UPDATED PART: FORK FOR DETACHING LINEN SYSTEM

Models: All G line models, starting from 01/06/2015

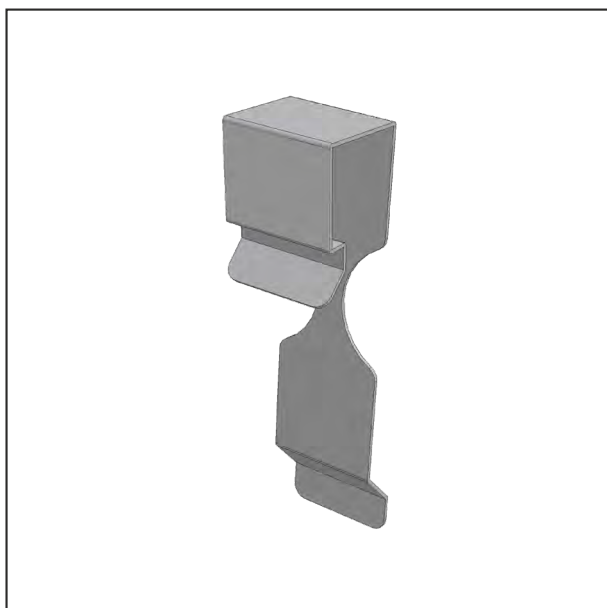
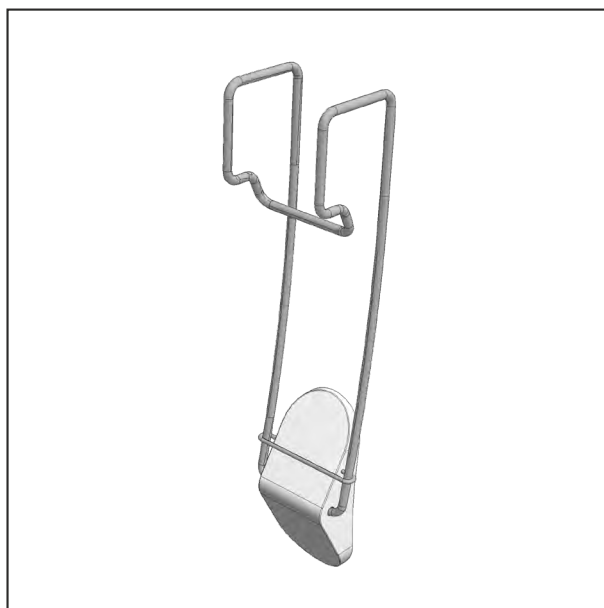
Note: New fork with teflon shoe **690000144-01**, compatible with the previous **609000169-01**.

It's easily applicable to all the previous versions of G 35 and G 50 ironers.

Part No.: 690000144-01

X06100: REPLACEMENT KIT

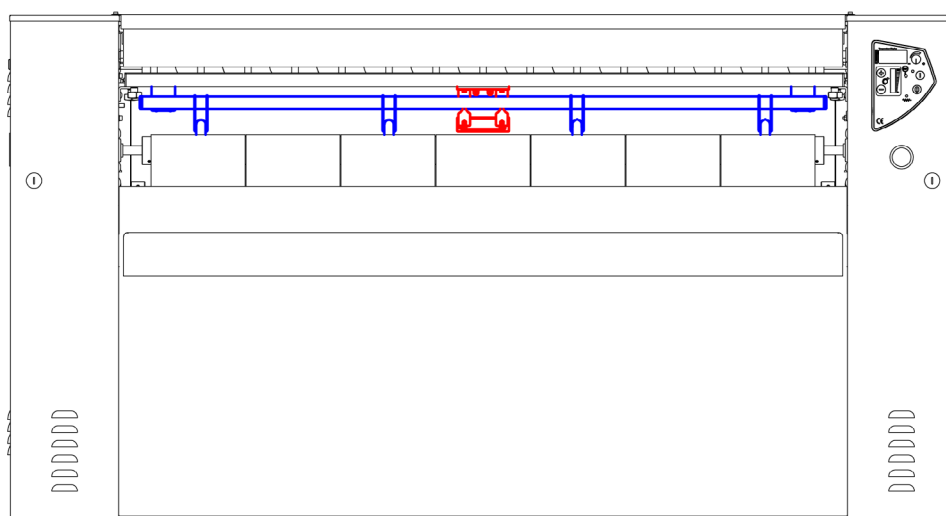
Models: G 25 ironers, through Serial No. 20150531xxxxx

Note: Replacement kit to apply the updated version of detaching linen system with forks **690000144-01**.

Part No.:	X06100	Replacement kit for detaching linen system
Bill of Materials:	(1) 609C00445-01	Tube for detaching linen system No. 1
	(2) 609C00443-01	Bracket for detaching linen system No. 2
	(3) 609000442-01	Cap for detaching linen system No. 2
	(4) 609Z00444-01	Plate support for feeler guide shoe No. 1
	(5) 690000144-01	Fork for detaching linen system No. 4
